ACCION NEW MEXICO
Regional Headquarters
2000 Zearing Ave. NW
Albuquerque, New Mexico

DRAWN BY RE
REVIEWED BY
DATE 07/24/09
PROJECT NO. 08-0111
DRAWING NAME
SITE PLAN AND PROJECT DATA

TEMPORARY DRAINAGE CERTIFICATION

GRADING AND DRAINAGE

SITE PLAN
1" = 20'

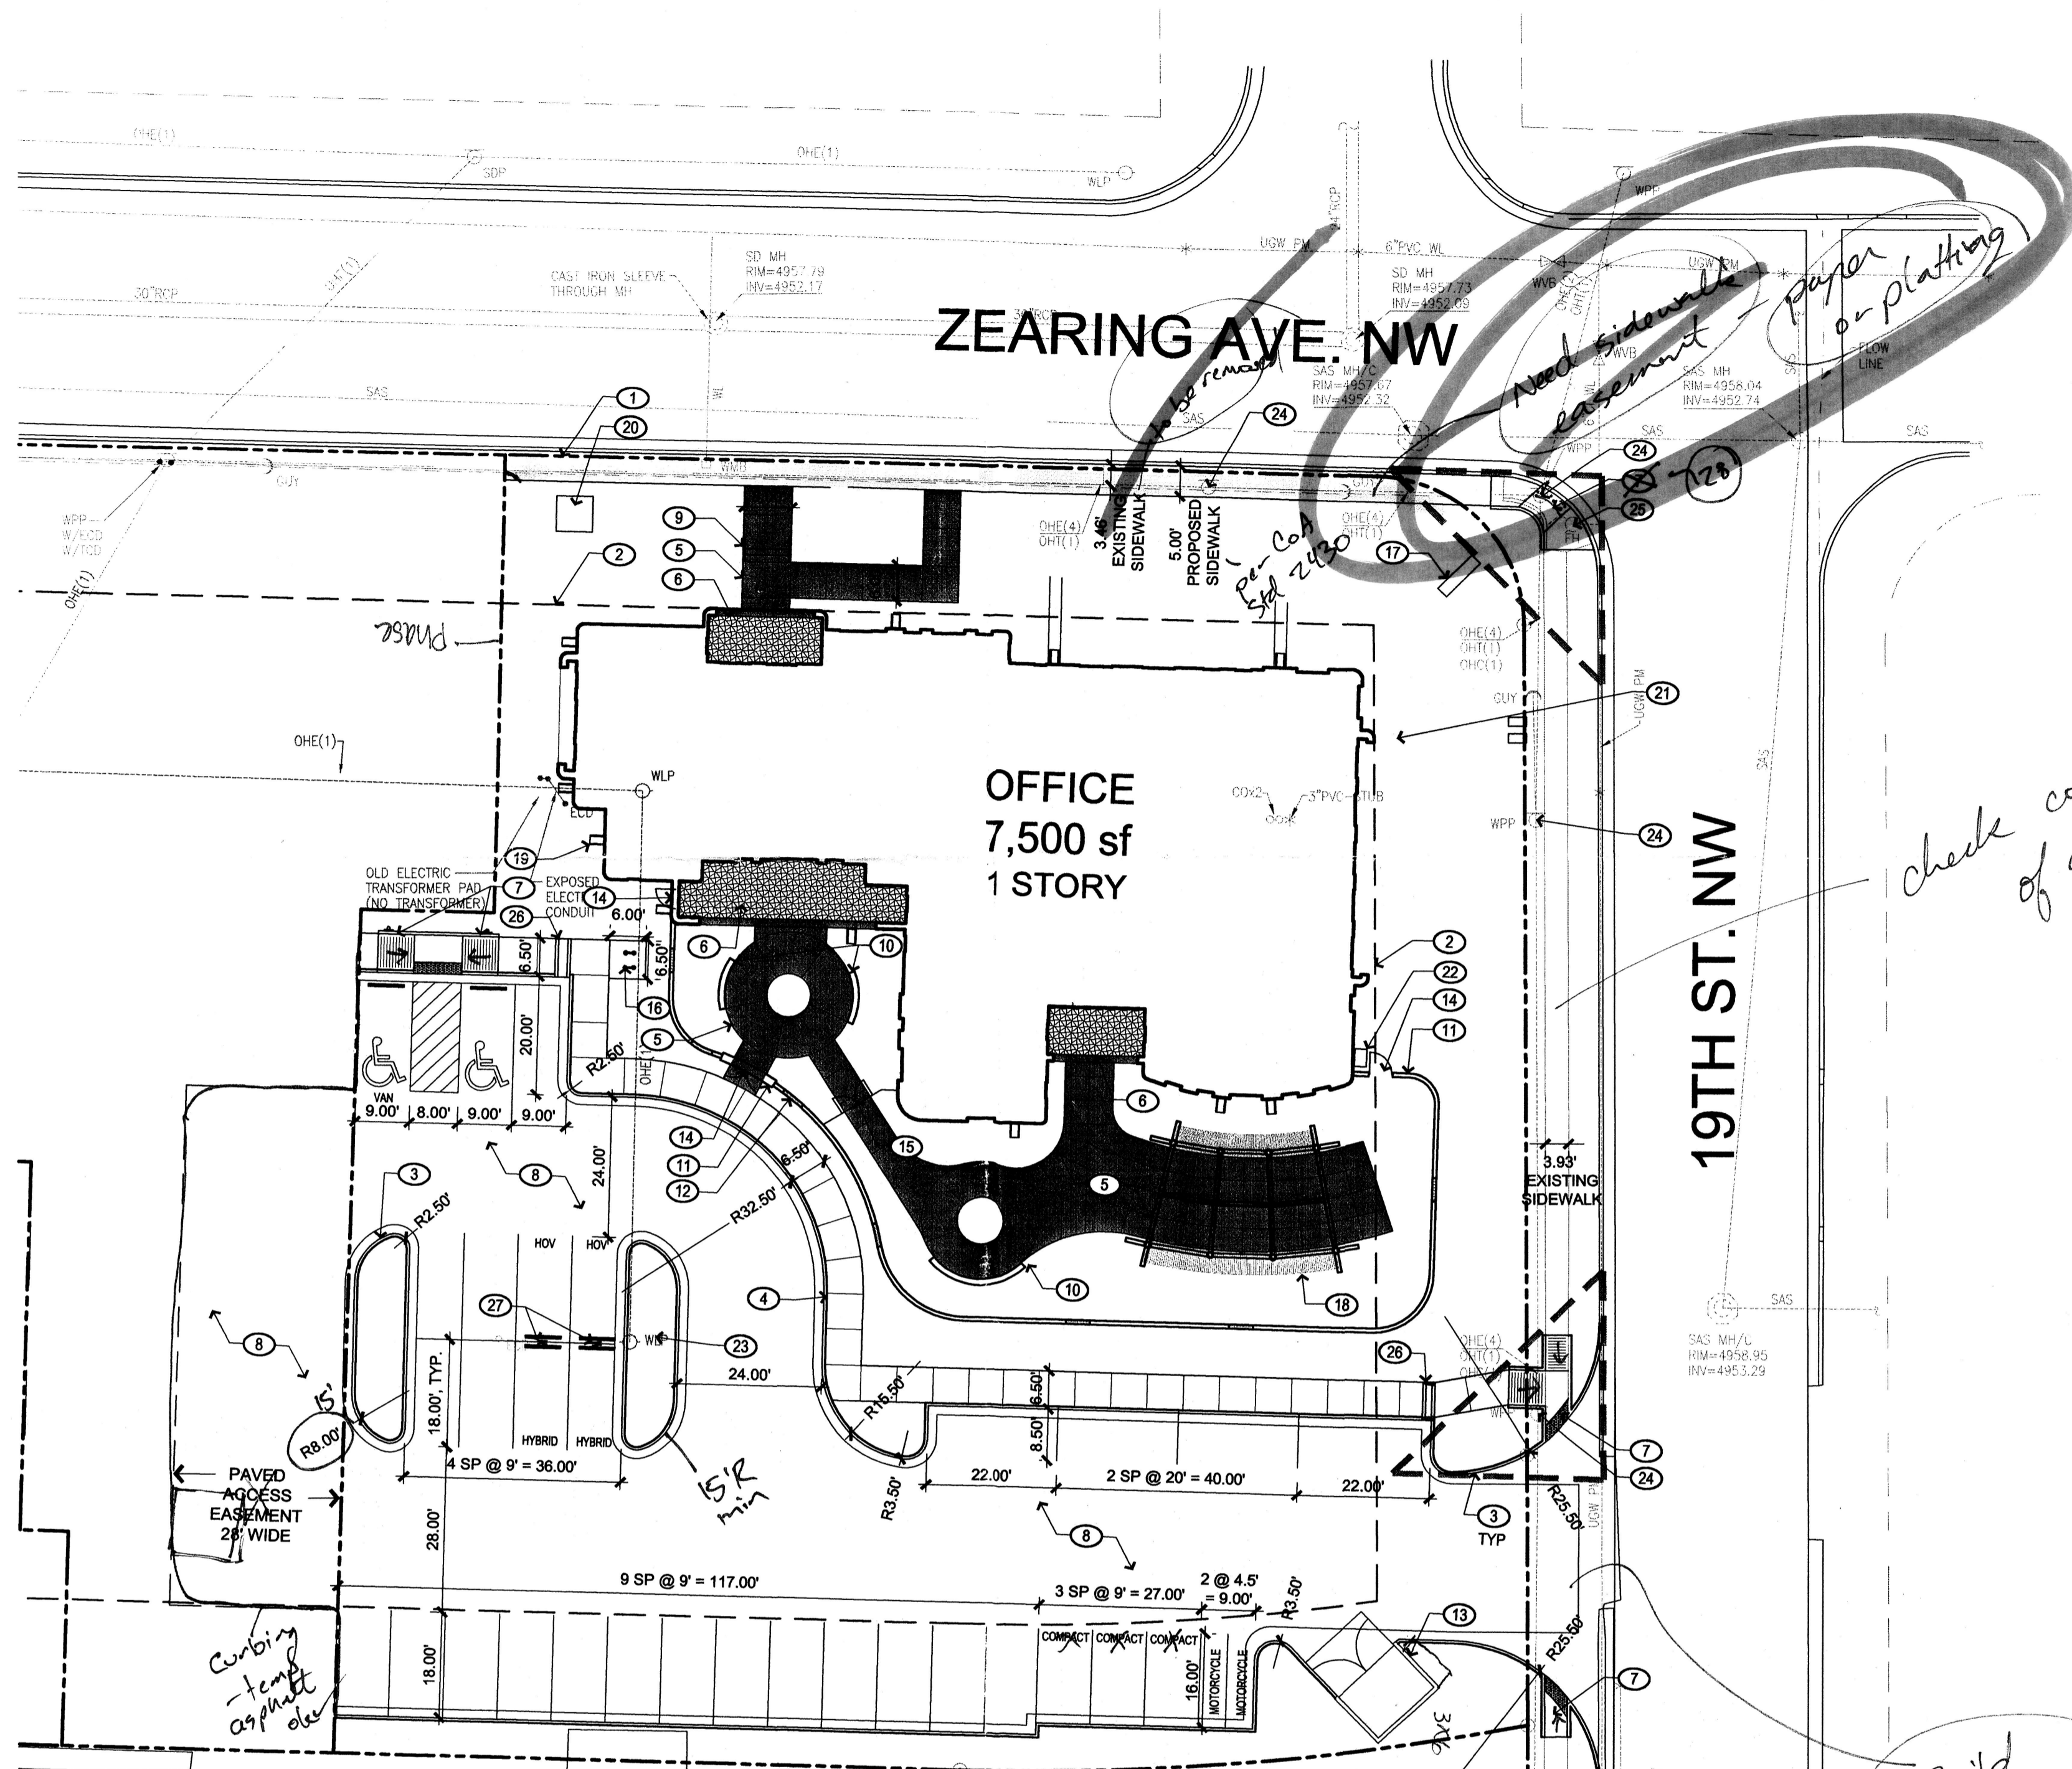
All ramps in City
Right of way must
have truncated domes

(28) New accessible ramp
per CoA Std 2441

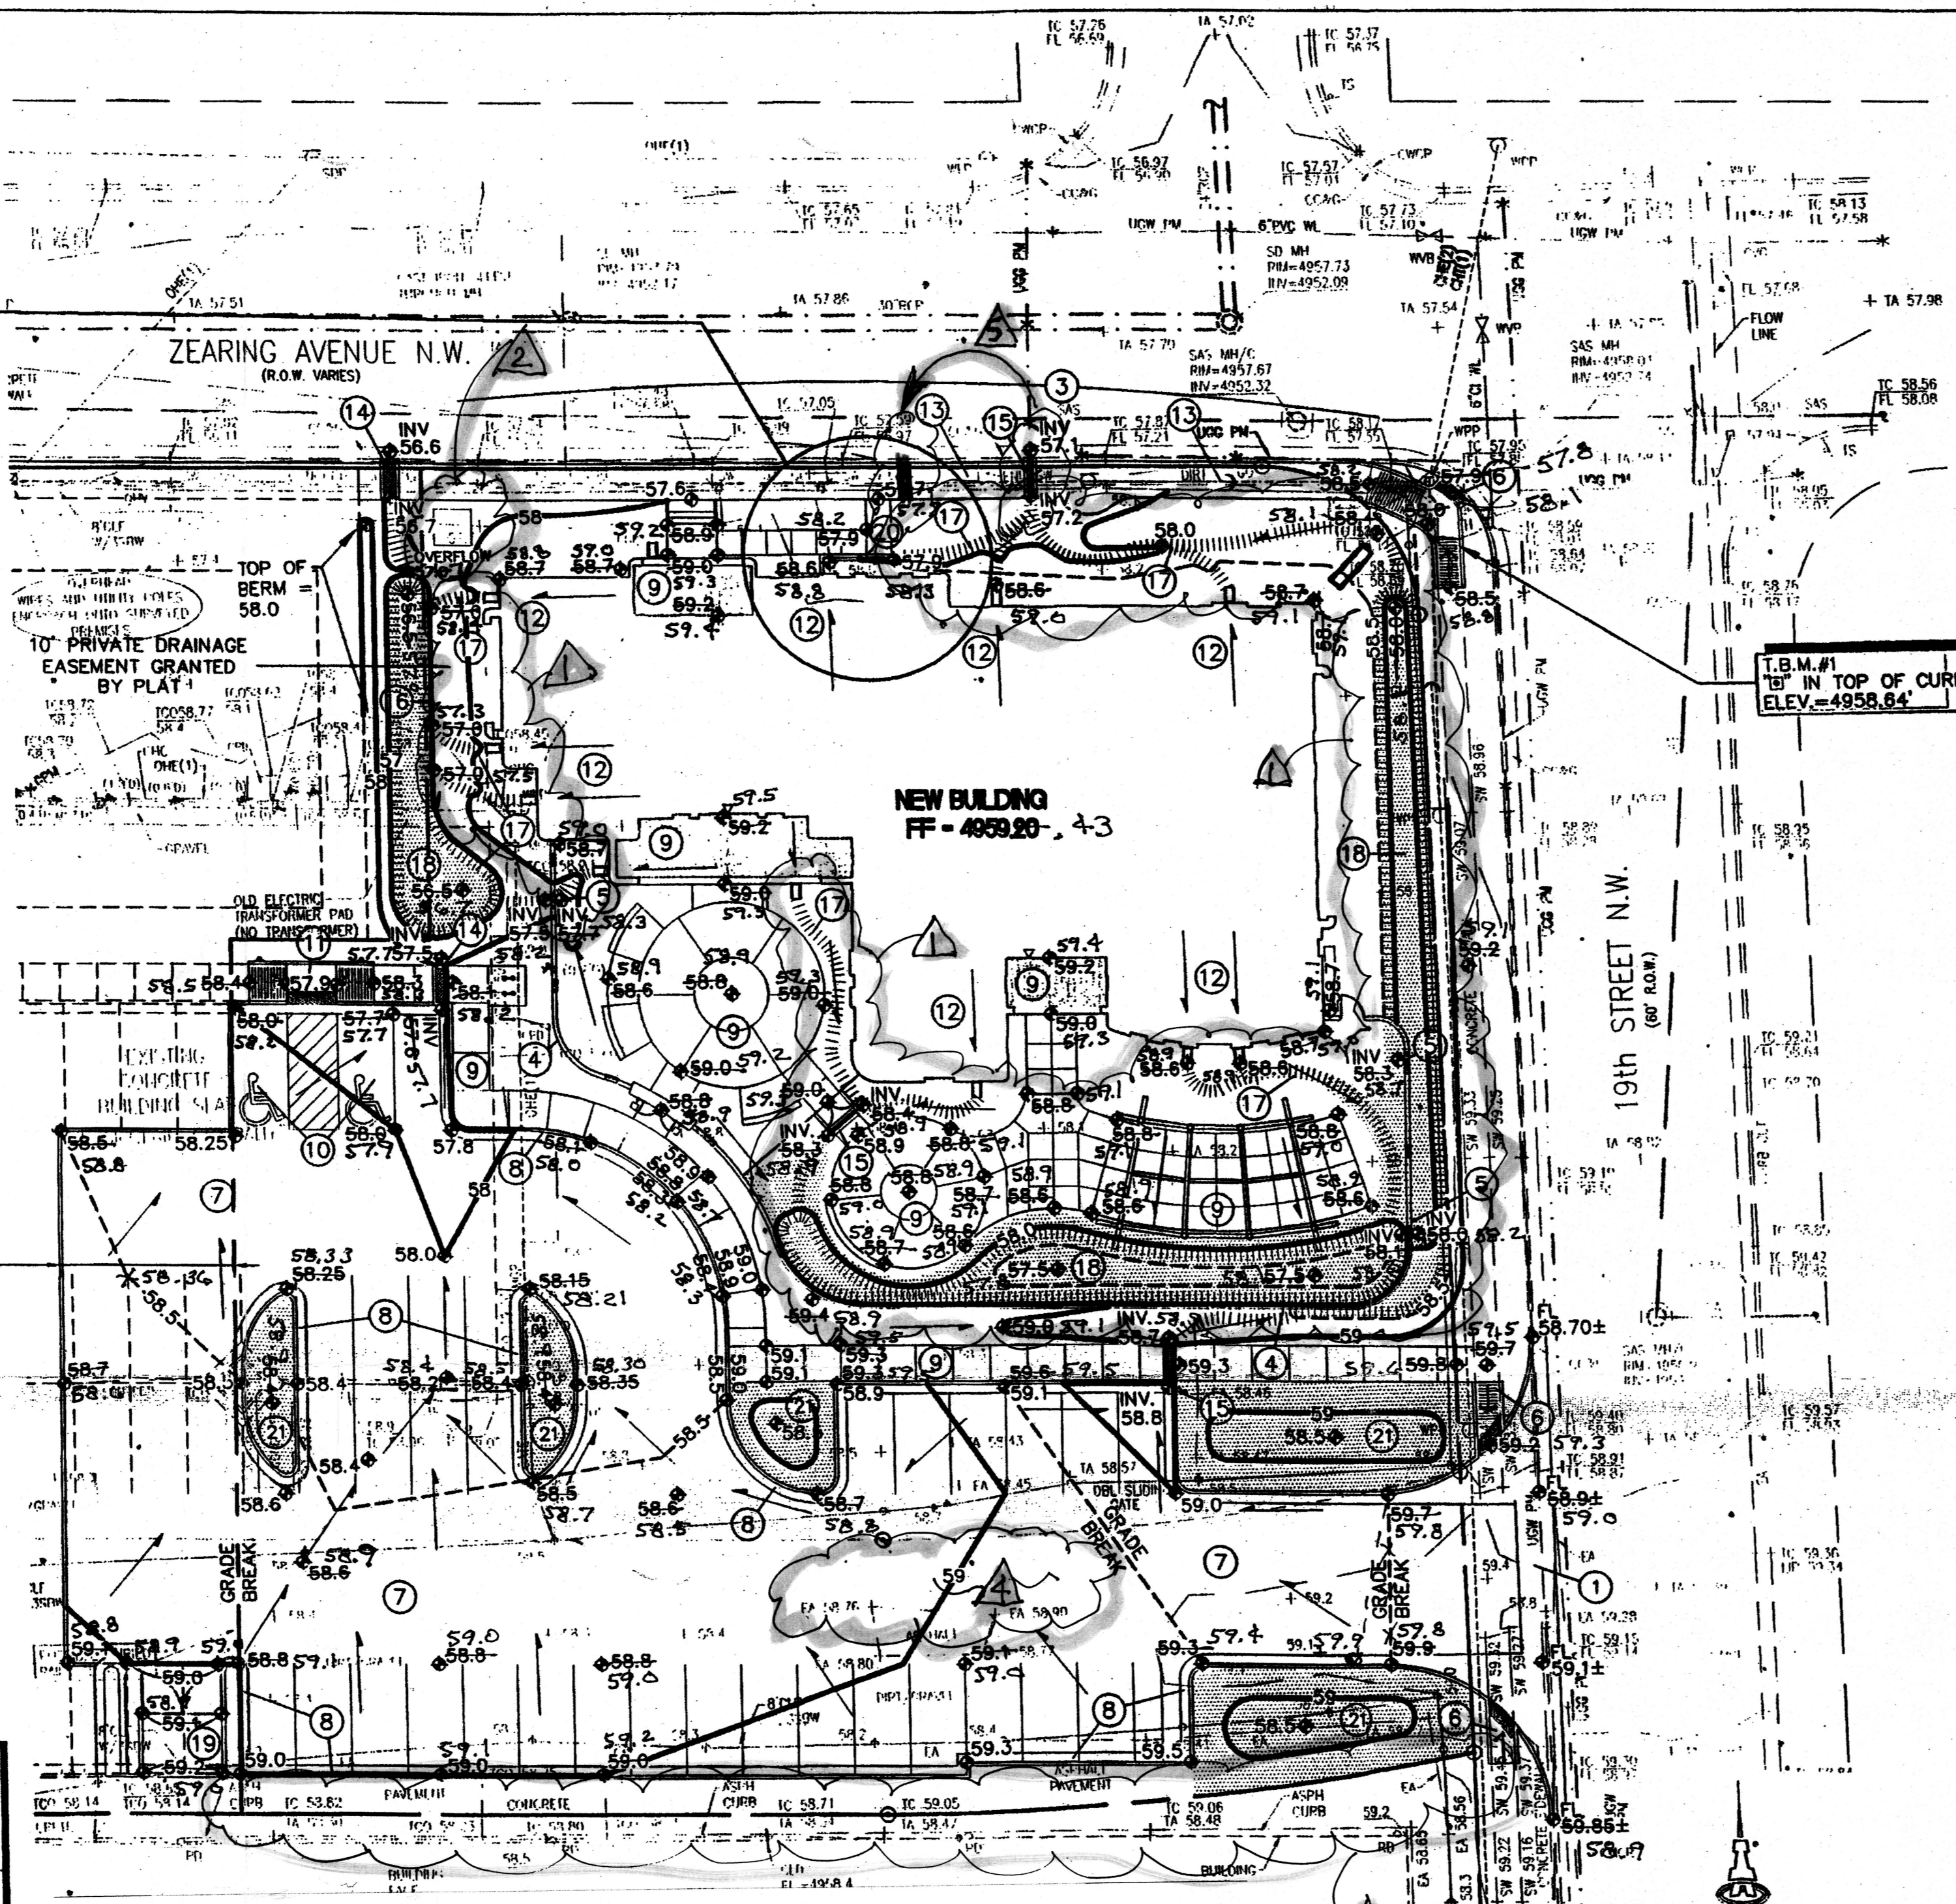
Spoke w/ Bob 9-3-10.
I told him that when he has a
crow out drive tearing it out and
they have more progress on the report,
I will look at it and give him a temp CO and
I will give him a temp CO and
count on him to do it right.
Curtis a few 9-3-10
OK - 9/24/10
cmc/45

1. Need to install fractured face rock swales to prevent erosion along drainage paths per keyed notes #16 & #17. Any gravel that is in place will need to be removed, the subgrade dug down to keep the top of rock at the surrounding grade, then the rock added.
2. There is a transformer installed on the NW corner of the building. The slope on the north side of the transformer is too steep. The gravel is sloughing off the landscape fabric. It needs fractured face rock or concrete slope protection.
3. Need additional survey shots on the retaining wall and pond that were added along the south edge of the parking lot during construction.
4. There is a minor bird bath in the parking lot.
5. The sidewalk culvert moved west.

DRAINAGE CERTIFICATION

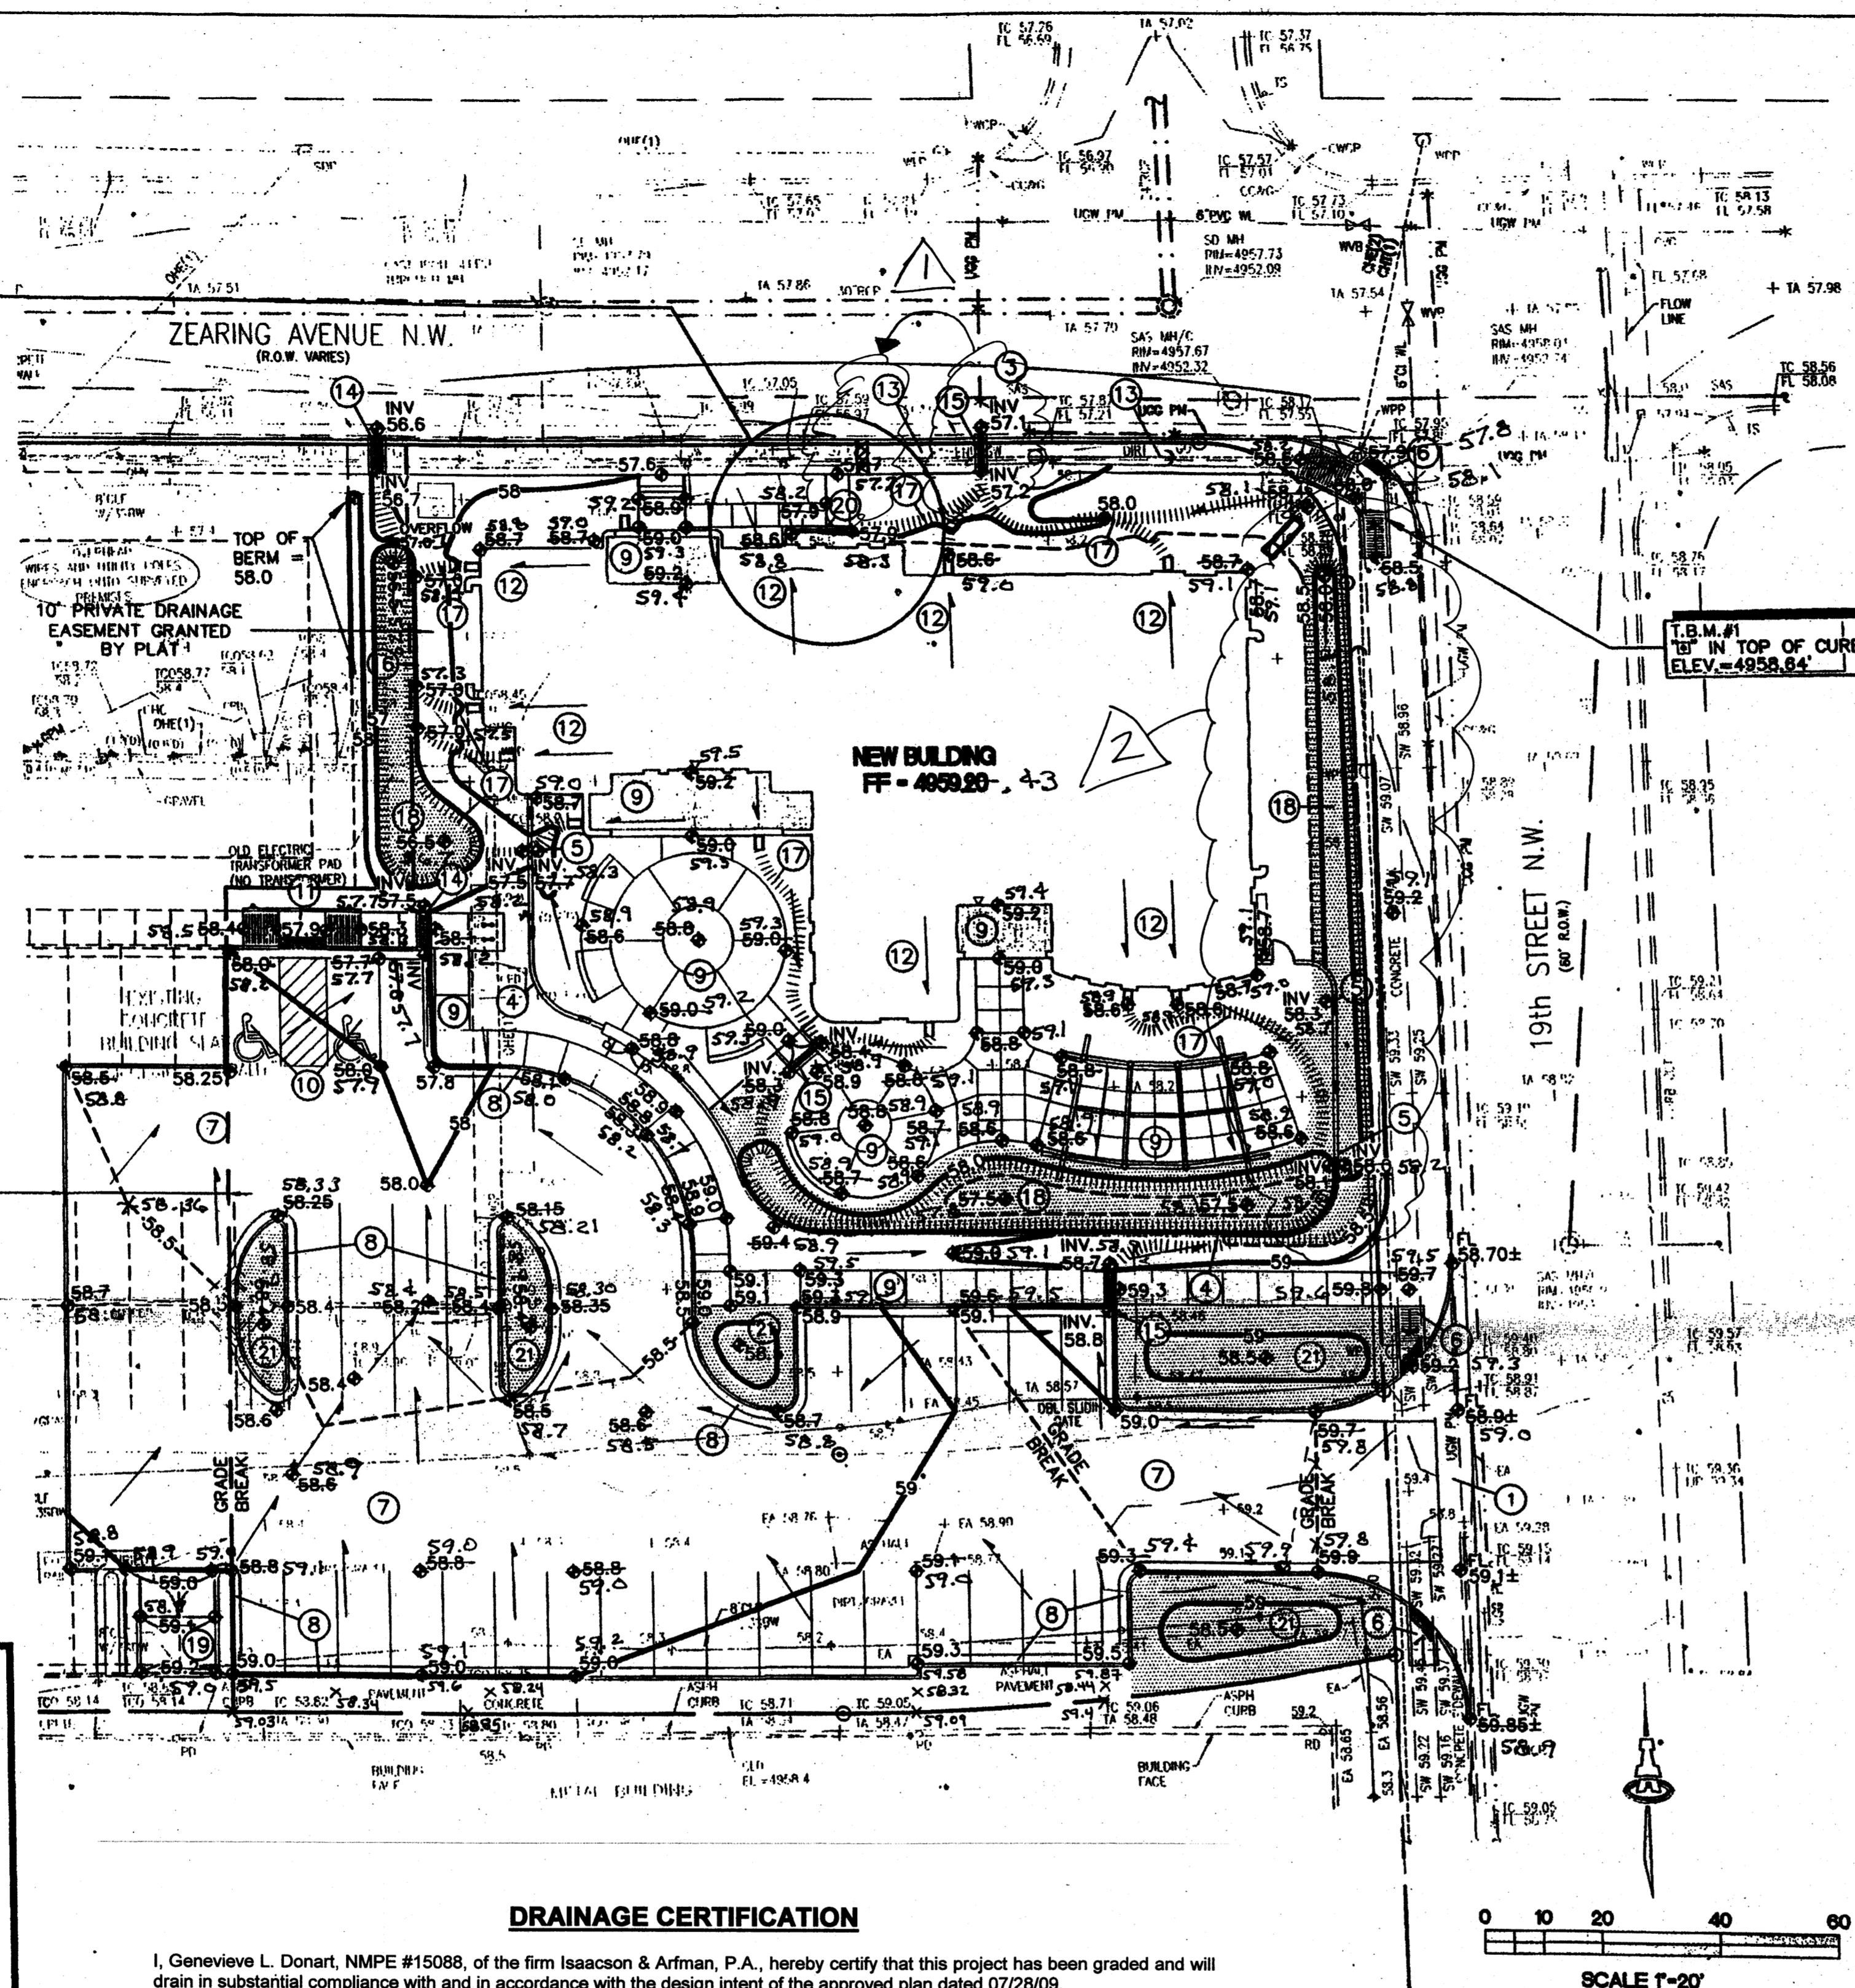
1. The sidewalk culvert moved west.
2. No cobble was installed on the east side of the building where constructed slopes are much shallower than designed.
